# FINDLAY CITY PLANNING COMMISSION

## STAFF REPORT April 12, 2018

# City of Findlay City Planning Commission

Thursday, April 12, 2018 - 9:00 AM

**C103**  
 SHEET NO.  
 SHEET TITLE

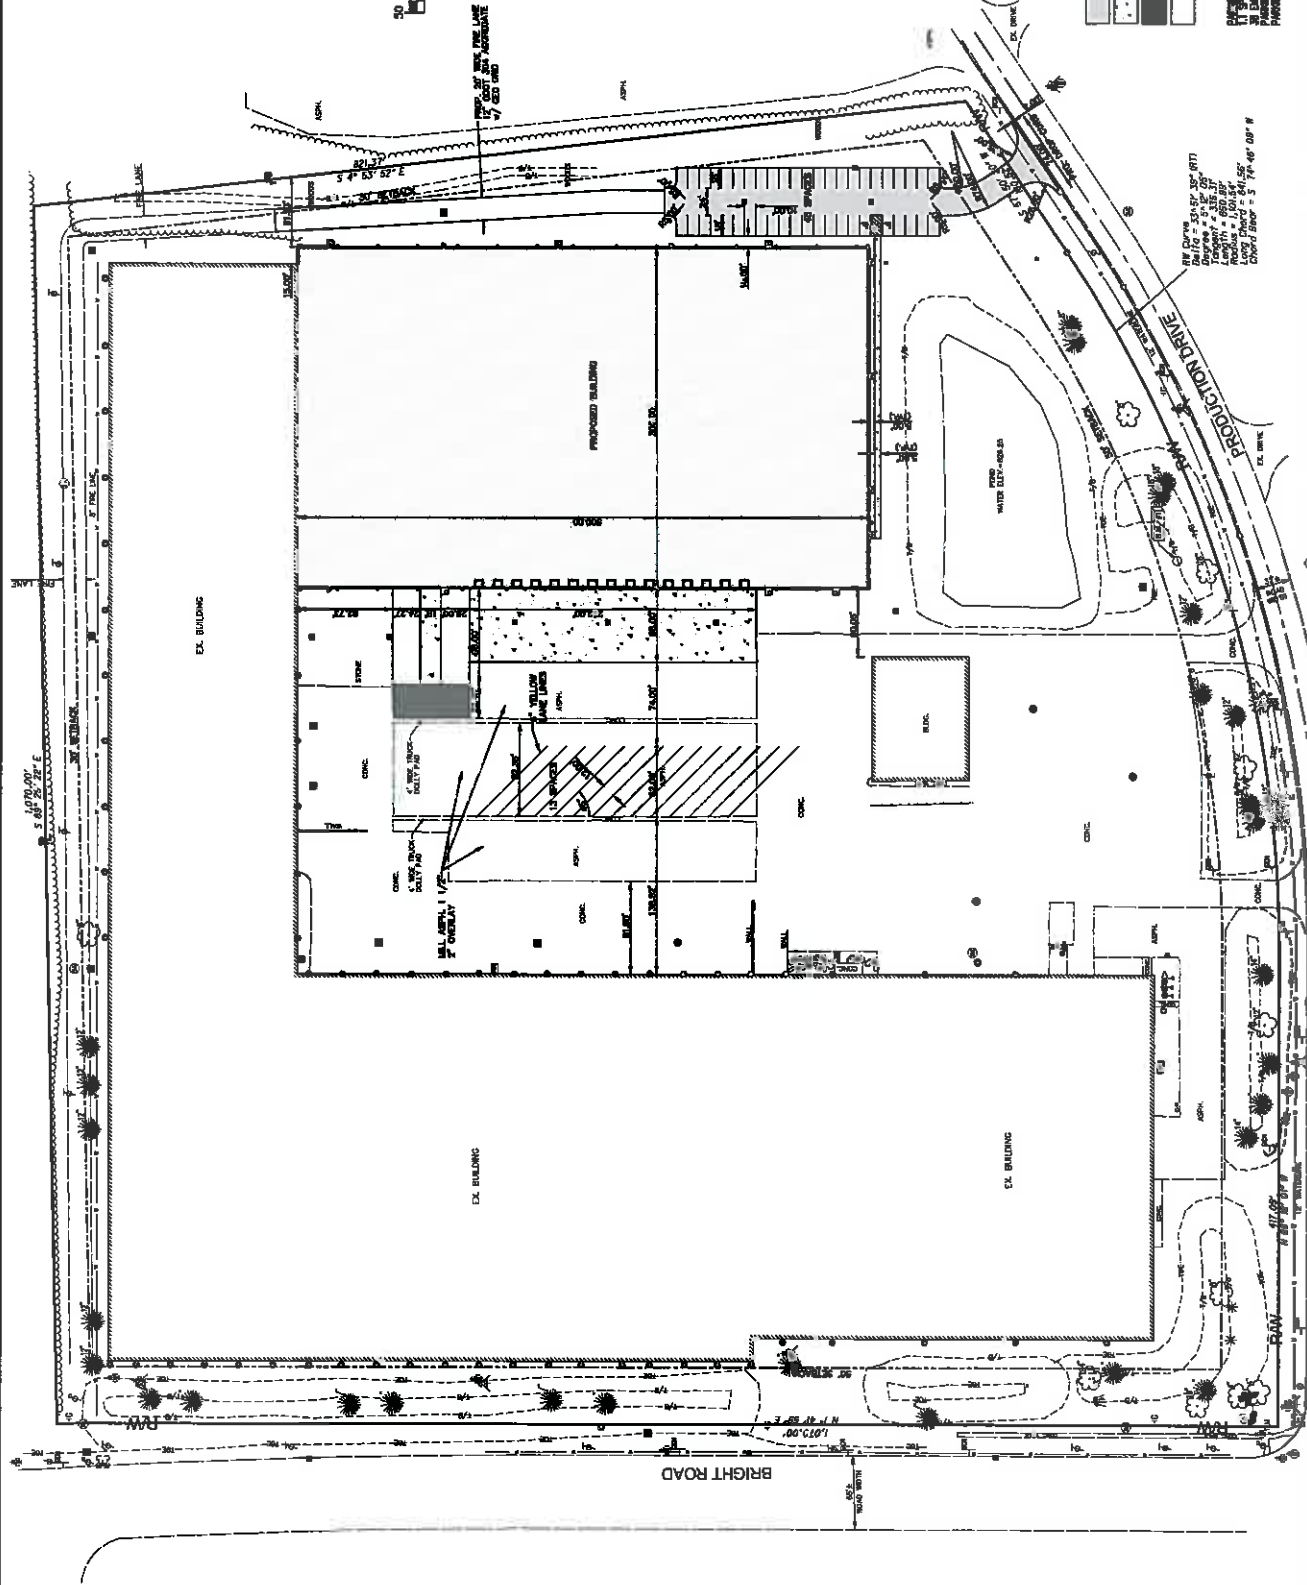
The proposed plans show a domestic and fire line to be installed for the new building. The fire line will be coming off of the existing 8-inch line that is located on the north side of the site. The

2-inch domestic line will be tied into the 12-inch water main located on the north side of Production Drive. As a note, the City of Findlay does not allow 90-degree bends to be installed on public waterlines.

Detention for the site is proposed to be provided by the existing detention pond. The consultant will need to verify that the pond does indeed comply with our current standards. Will continue to work with the consultant.

- Verify volume in detention pond
- Ex Catch Basin in fire lane need Raised/ Lowered?
- Tops on all CB's seem to be 100 FT too low.

- Verify Volume in Detention Pond
- Adjust Catch Basins on plans

- **Submittal of a landscaping plan for the parking lot (HRPC)**
- **Extend the 8" fire line (located to the east of the proposed warehouse) to the south with three hydrants spaced evenly. (FIRE)**
- **The fire lane (located to the east of the proposed warehouse) shall be 25' wide. (FIRE)**
- **Extend the drive northward to the northeast corner of the existing warehouse building. (FIRE)**
- **Apply for all necessary permits with Wood County Building Department. (FIRE)**
- **Verify Volume in Detention Pond (ENG)**
- **Adjust Catch Basins on plans (ENG)**
